CITY of NOVI CITY COUNCIL

Agenda Item 3
September 26, 2016

SUBJECT: Consideration of tentative approval of the request of McBride Dale Clarion for Speedway at 14 Mile and Haggerty, JSP 16-13, with Zoning Map Amendment 18.714, to rezone property in Section 1, located at the southwest corner of Fourteen Mile Road and Haggerty Road from OST (Planned Office Service Technology) and B-3 (General Business) to B-3 (General Business) subject to a Planned Rezoning Overlay (PRO) Plan Agreement, and corresponding PRO Concept Plan. The property totals 2.03 acres and the applicant is proposing to update and rebuild the whole site.

STORE OR BLDG NO. **2224**
 VERSION OR PROJECT ID **95505**
 SCALE **1/8" = 1'-0"**
 DESIGN TEAM **DATE**
 P. MGR. **STORTENBECKER 4/7/16**
 RYMR.
 DRWG. NO. **2224-ELE**

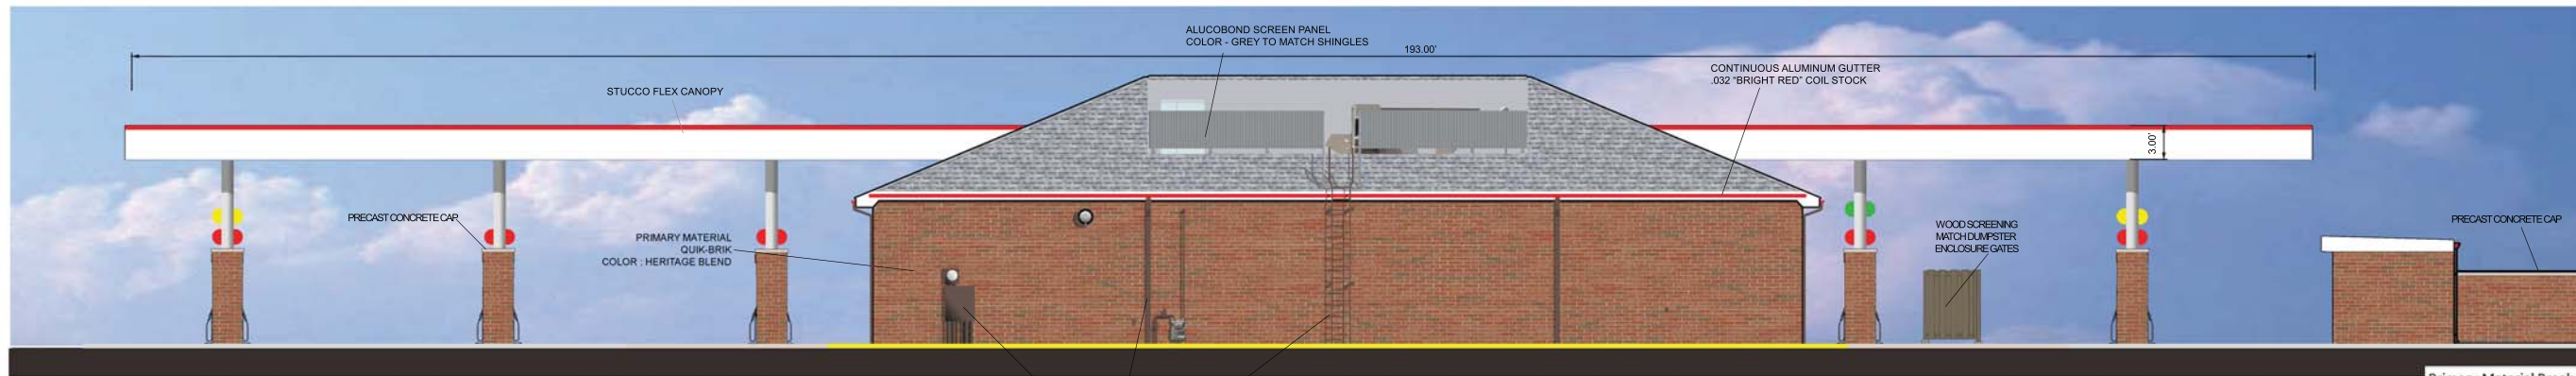
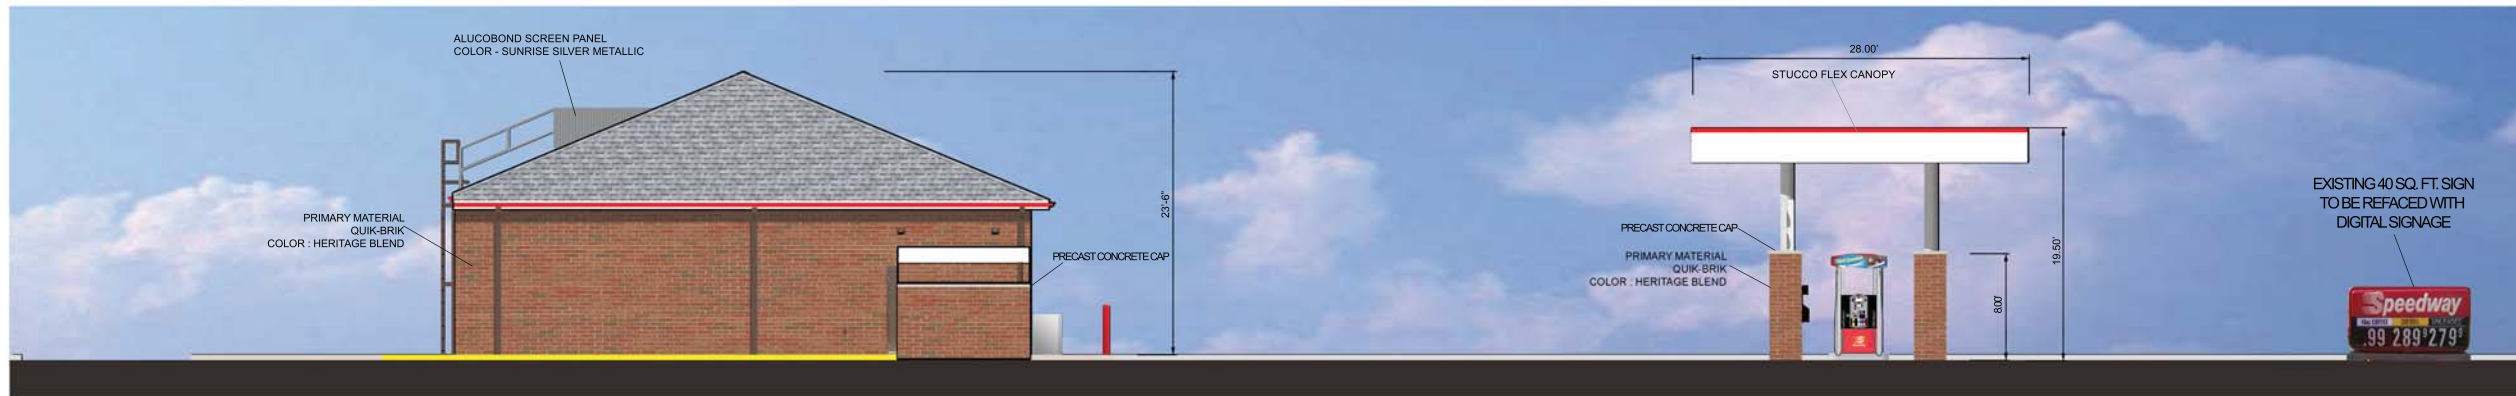
1. Speedway is requesting a waiver for the asphalt shingles as shown on the building elevations. See sheet 2224-ELE.
2. Speedway is requesting approval of the elevations as provided in the submittal packet.
3. Speedway will work with staff on the revised elevations to ensure compliance with City regulations.
